Fulton County, Indiana County Road 350 N

DRAFT Detailed Project Report and Environmental Assessment

SUBJECT: Approval of Draft Detailed Project Report & Environmental Assessment, Section 14
Project, County Road 350 North, Fulton County, Indiana

SHEET REFERENCE NUMBER:
CS102
SHEET ___ OF ___

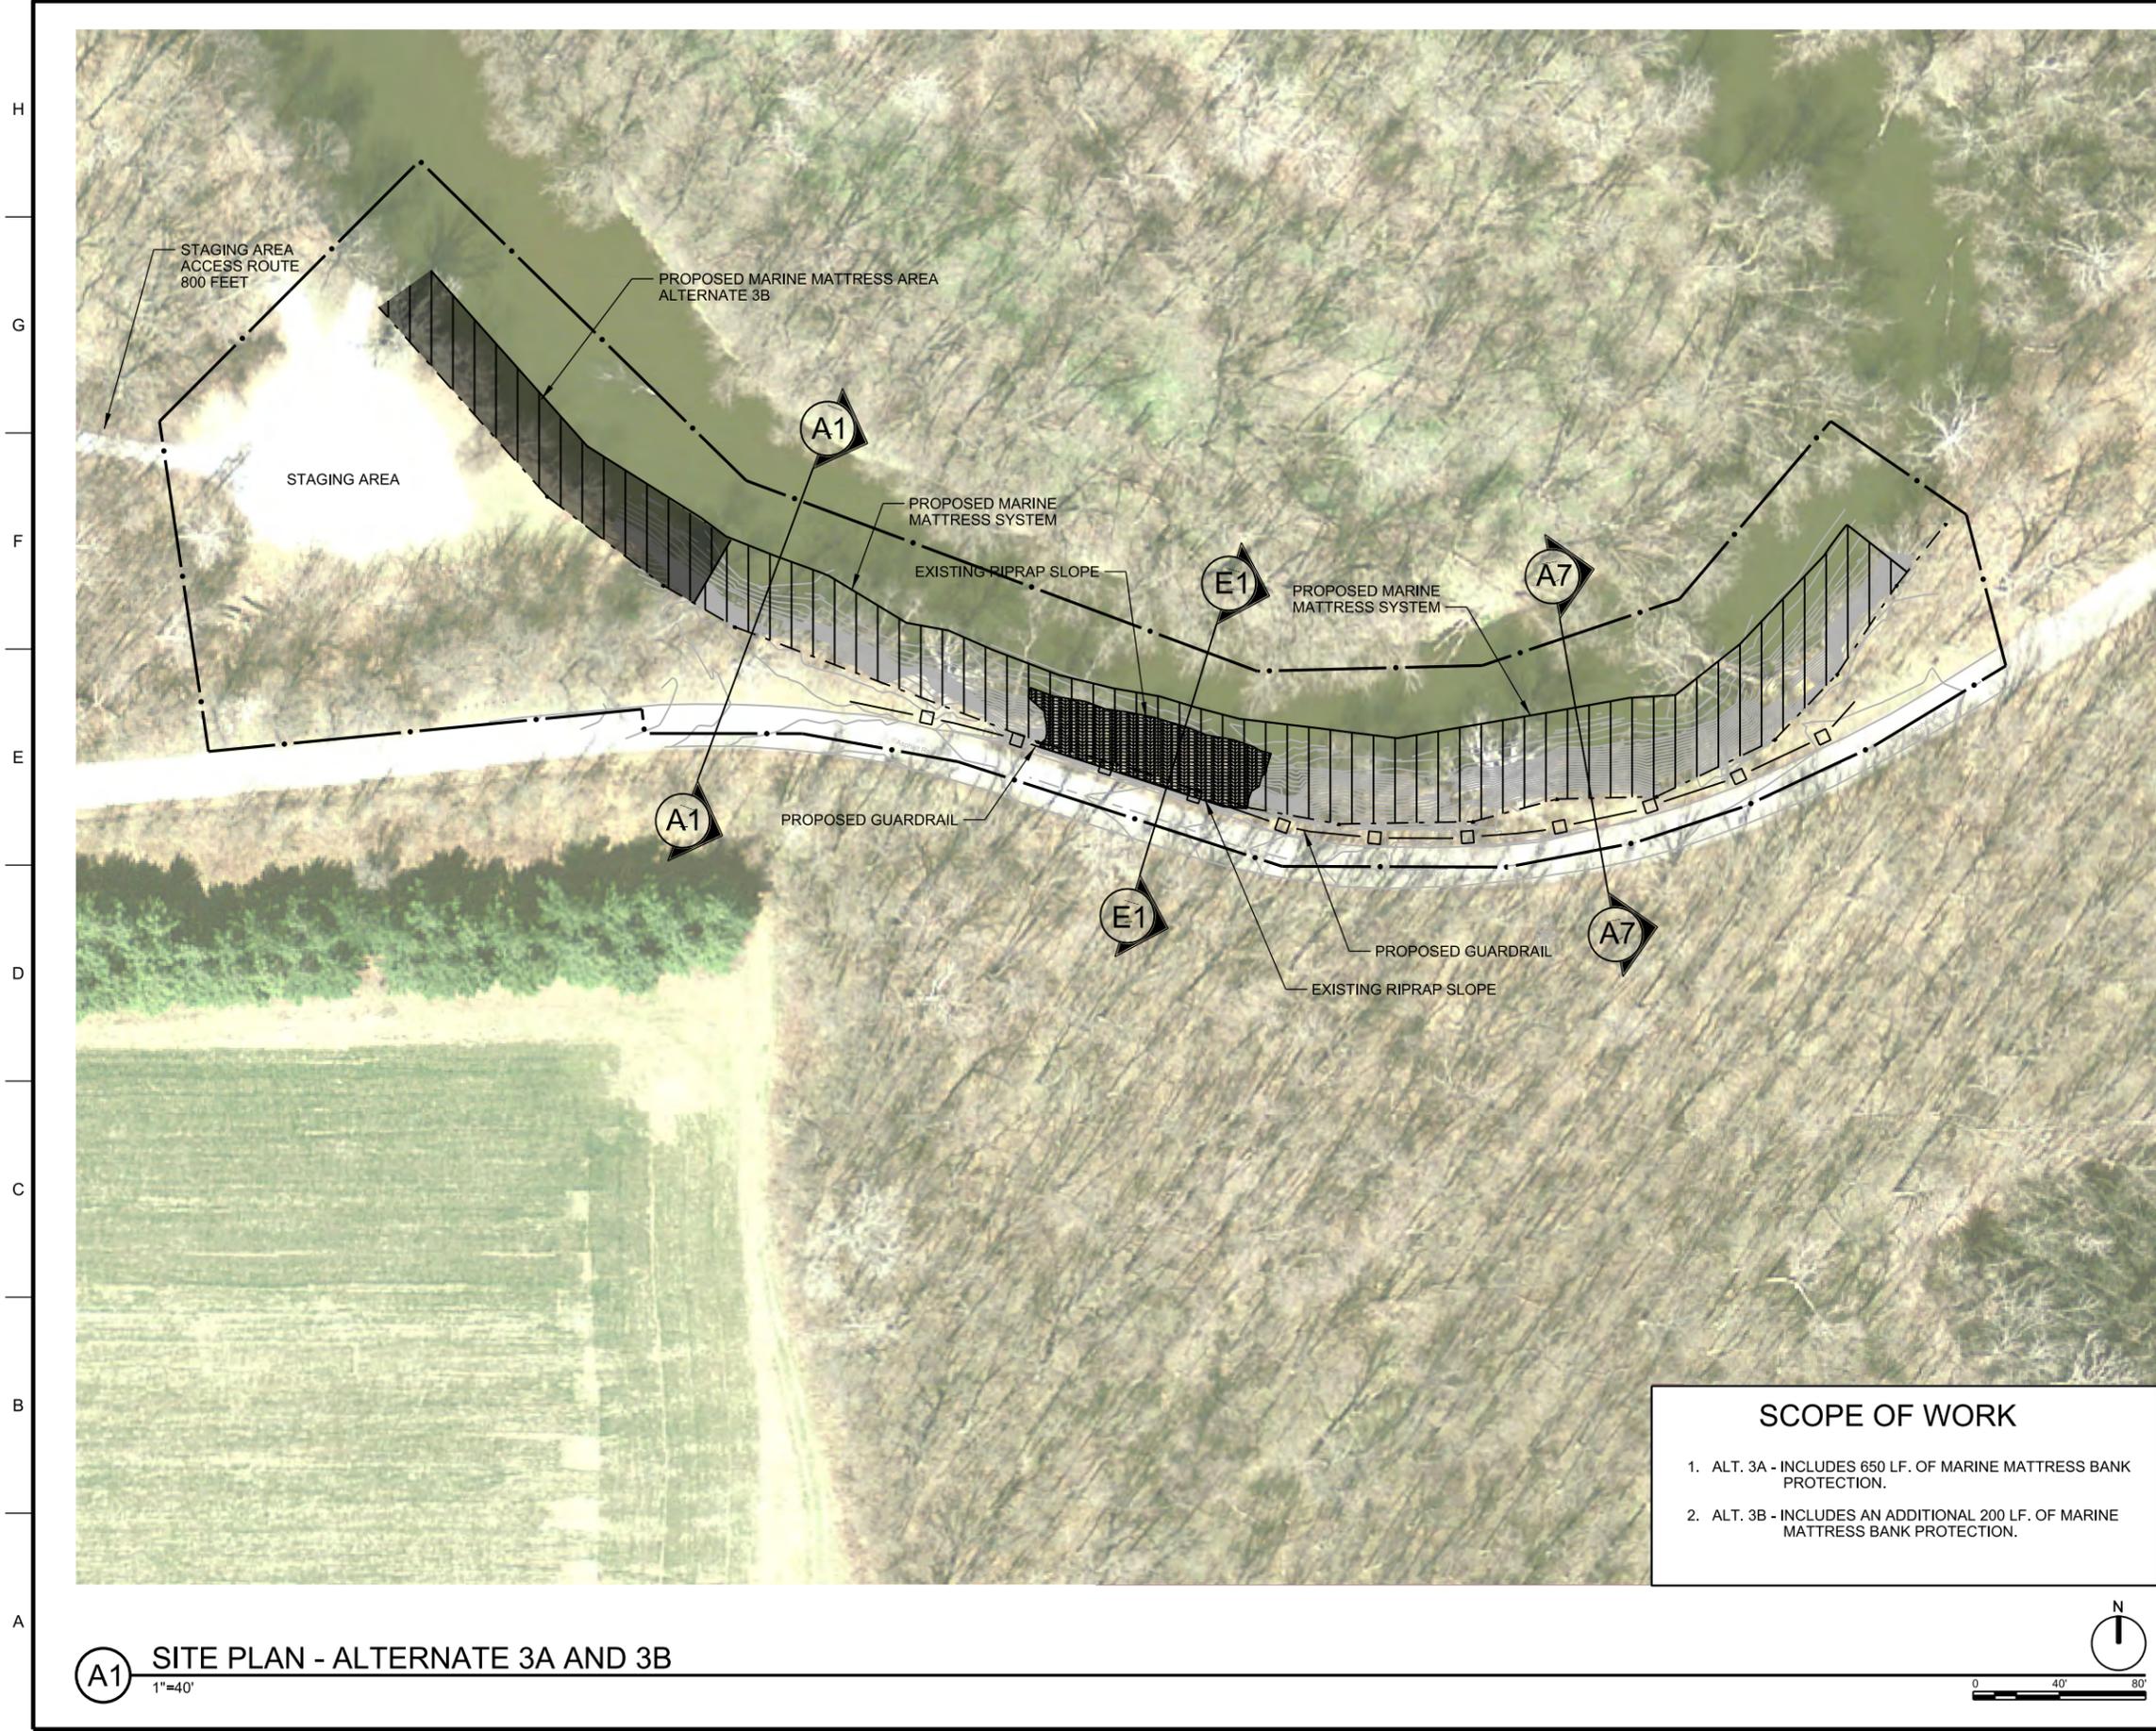
Sheet CS101-CS103: There are no cross-section cut lines shown in plan to locate the typical sections. Suggest adding the cross-section cut lines to the respective plan views.

Sheet CS103: The plan shows new riprap limits, but no new riprap is proposed for the marine mattress alternative. Presumably, this was a drafting oversight. Suggest removing the riprap line symbols from the plan and legend since none is shown on the typical sections. Also, the limit of the existing riprap to be covered by the mattresses should be shown on the plan.
